Constraints from CAST

Proposal 1

Proposal 2

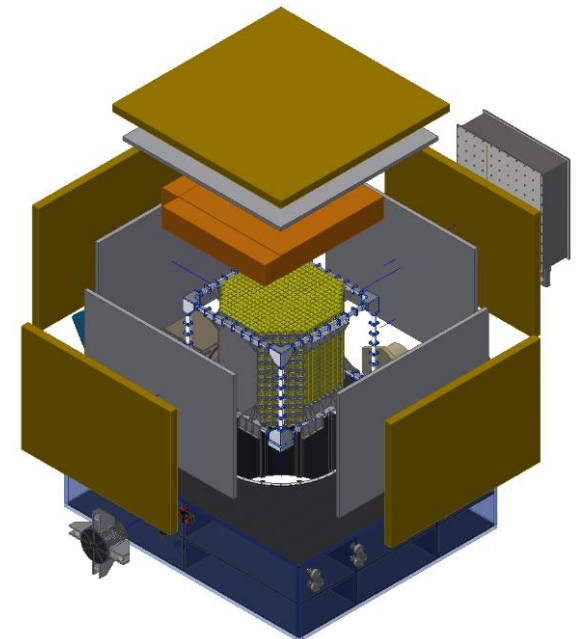
- Separate HERD into HERD main and a bridge
 - HERD main < 3t to fit the small arm capability
 - The bridge <0.5t(?) and overall HERD <3.5t
- Height of HERD detectors above EM I is <1.1m
- Remove side FIT
 - Shrink all envelope dimensions
 - Reduction of area of PSD, SCD and general

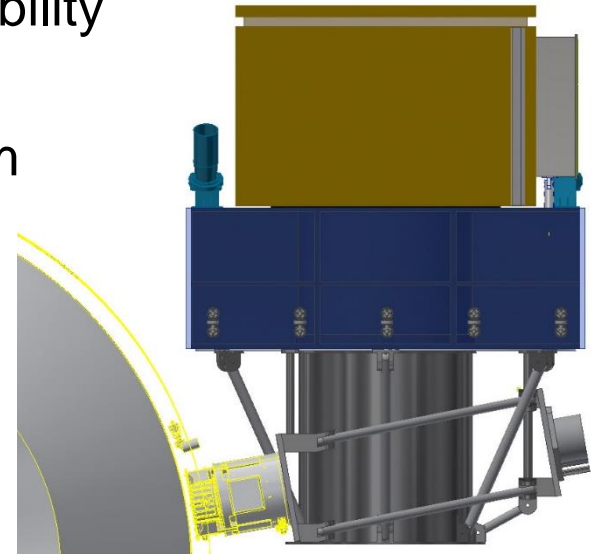
- One HERD <3.6t to fit the enhanced arm capability
 - Installation feasibility study needed
- Height of HERD detectors above EM I is <1.1m
- All five-side detectors remained
 - More compact design
 - Common supporting structure
 - Robust and removable structure

Proposals comparison

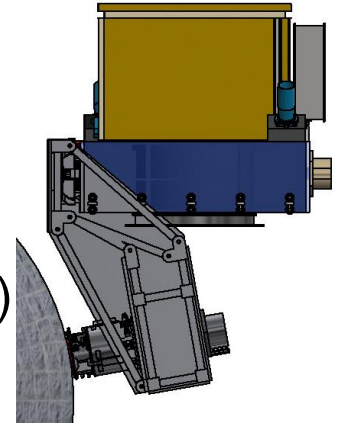
- CMSA officials were not satisfied with the feasibility of proposal 1 and proposal 2.
- CSU & IHEP are working on proposal 3 based on half-open cargo ship and combined arm. (layout similar with proposal 1)
 - Keep as many as possible detectors, (TOP+ 2 SIDE FIT)
 - General electronics and power units moved to bridge
 - Customized connection between HERD main and bridge
 - To meet the requirements from robotic arm
 - Mechanical connection first, then electronic and thermal
